6C Containment Debris Protection for ECCS Strainers

STD DEP 6C-1 (Figure 6C-1)

STD DEP Vendor

Figure 6C-1 Cassette Strainer Cutaway

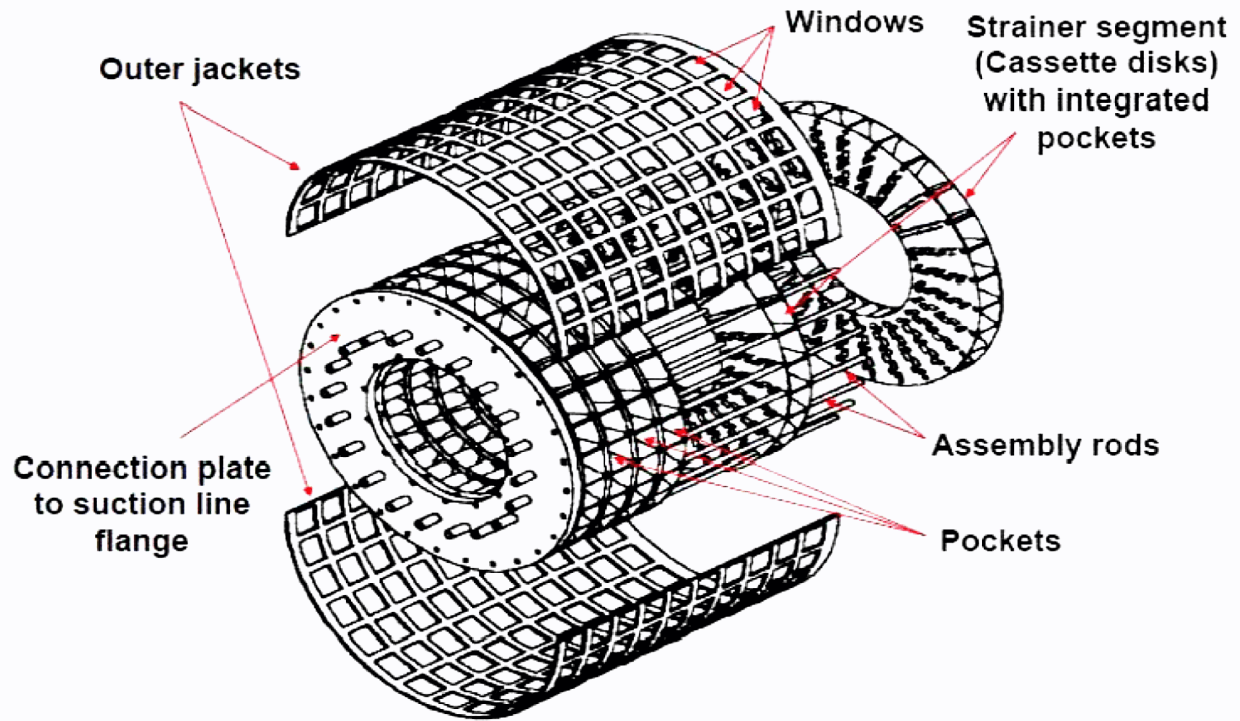
The information in this appendix of the reference ABWR DCD is subject to several changes due to the adoption of a complex ECCS strainer design (e.g. Cassette Type Strainer). Consequently, for clarity it is presented in its entirety with the following departures incorporated. This strainer design has been used at numerous BWRs in Japan and numerous PWRs in the United States. The strainer is described in this appendix. Departure STD DEP Vendor changes General Electric (GE) to Toshiba in Section 6C.1.

The suction strainers design at Perry preceded and did not meet the current regulatory requirements. The ABWR ECCS suction strainers will utilize a "T" arrangement with conical strainers on the 2 free legs of the "T" a cassette type strainer design. This design separates the strainers so that it minimizes the potential for a contiguous mass to block the flow to an ECCS pump. The design of the strainers will be based on Regulatory Guide 1.82, NUREG/CR-6224 (Reference 6C-4), NUREG/CR-6808 (Reference 6C-5) and the Utility Resolution Guidance, NEDO-32686-A. The cassette type strainer design is based on a set of cassette modules with U-shaped filter pockets attached to the cylindrical outer jacket. Each strainer consists of filter modules, the outer jacket and flange plates on each end of the cylindrical assembly. The filter module is constructed with cassettes which are arranged axially along the strainer axis. One cassette consists of pocket shaped filters which are arranged radially. A cut-away drawing of the strainer is shown in Figure 6C-1. The material used in the cassette type strainer is stainless steel. The cylindrical strainer assemblies are mounted in pairs on piping tees at each ECCS pump suction line. When the ECCS pump operates, the suction flow in the suppression pool runs into all pockets through the outer jacket windows. Each pocket has five flow paths from the inlet through the five perforated walls to the outlet of the pocket towards the cassette strainer. By using the cassettes with the pocket shaped filters, the strainer has an available filter area which is larger per volume than cylindrical and other shaped strainers. The number of cassettes and pockets is adjusted to produce a specific head loss performance for the strainer. To avoid debris clogging the flow restrictions downstream of the strainers, the size of the holes in the perforated sheets is chosen by considering specific flow paths of ECCS equipment and piping (for example, the containment spray nozzle and the ECCS pump seal cooling flow orifices). The strainers will have holes no larger than 2.1 mm.
